Sir Bernard Jenkin MP: Response to Norwich to Tilbury Consultation. July 15th 2024.

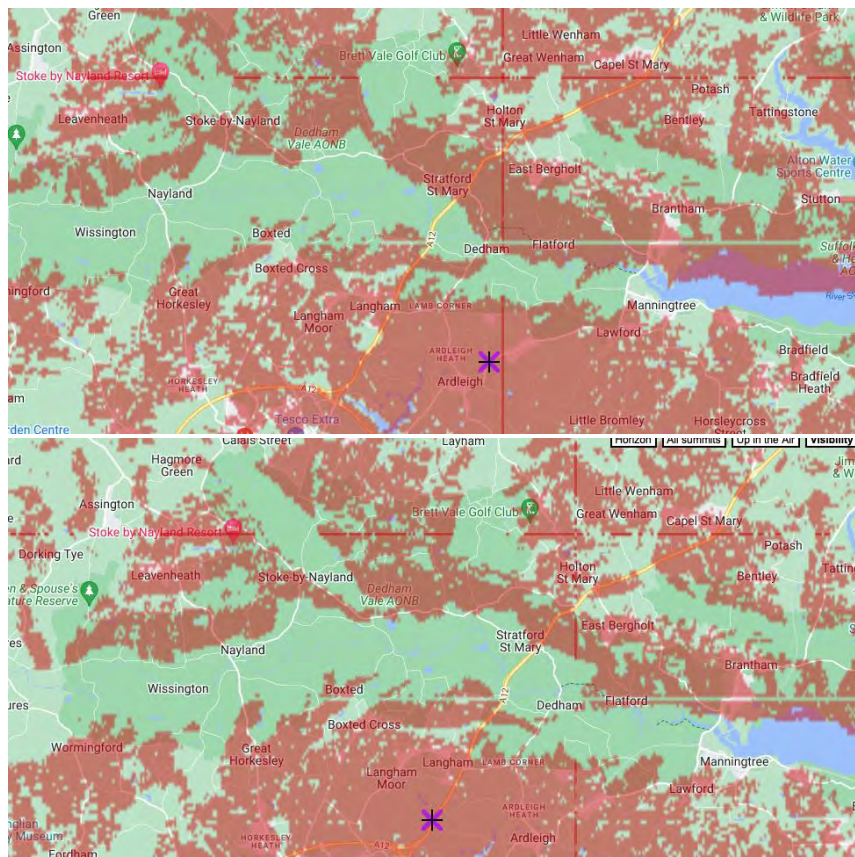
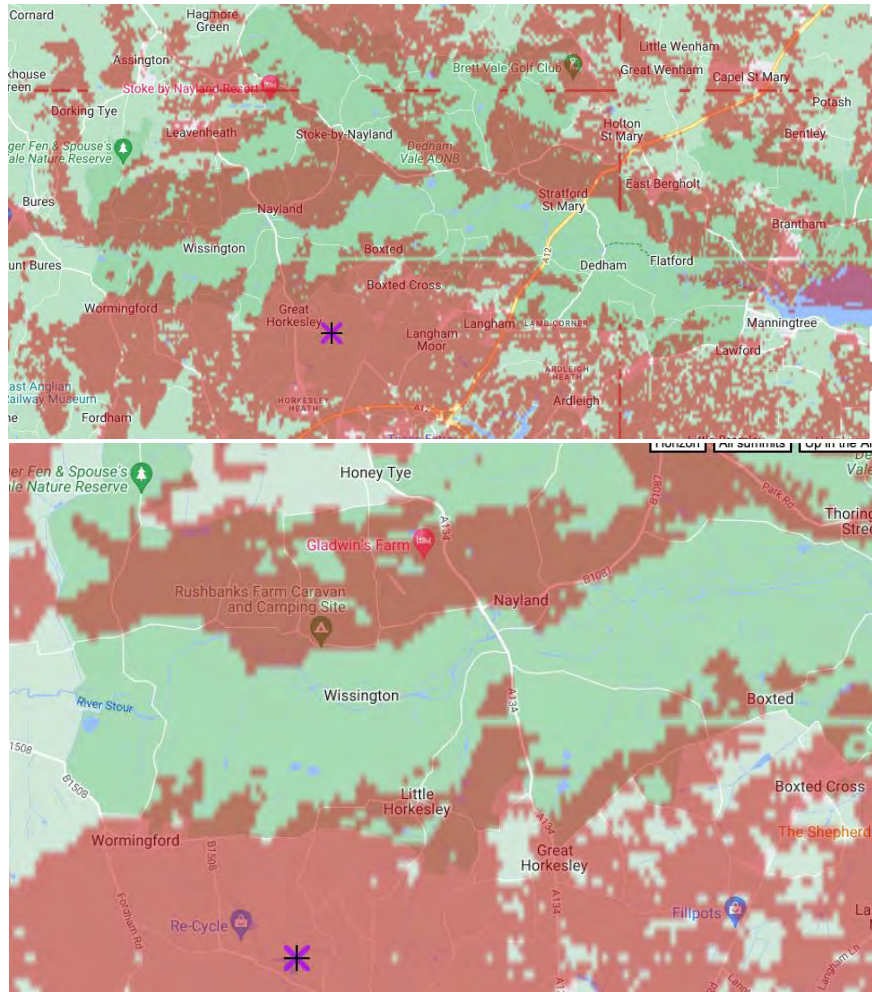
2.3.12 Figure 13.8.1 illustrates that, in the determination of National Grid, “some” pylons will be visible across a large proportion of the Dedham Vale, there are many locations within it from which between 11 and 30 pylons will be visible, and some sites at which between 50 and 60 pylons will be visible.

2.3.13 Figure 13.8.2 illustrates that, in the determination of National Grid, the full structure of pylons will be visible across large portions of the Dedham Vale. These facts taken together suggest that damage will be very significant.

2.3.14 The methodology employed in the construction of these figures is set out at 13.5.4 of the document “Preliminary Environmental Information Report – Volume I – Main Text”, which states: ‘The emphasis of this preliminary assessment is based on landscape and visual receptors within 3km of the operational overground elements of the Project and 1km of the operational underground cable route where it is considered that significant landscape and visual effects are most likely to occur’ and at 13.5.5 which states that ‘More distant viewpoints up to 5km from the Project are considered where there is the potential for significant visual effects to arise beyond the 3km study area, for example where there are particularly sensitive visual receptors and where topography allows more far-reaching views’
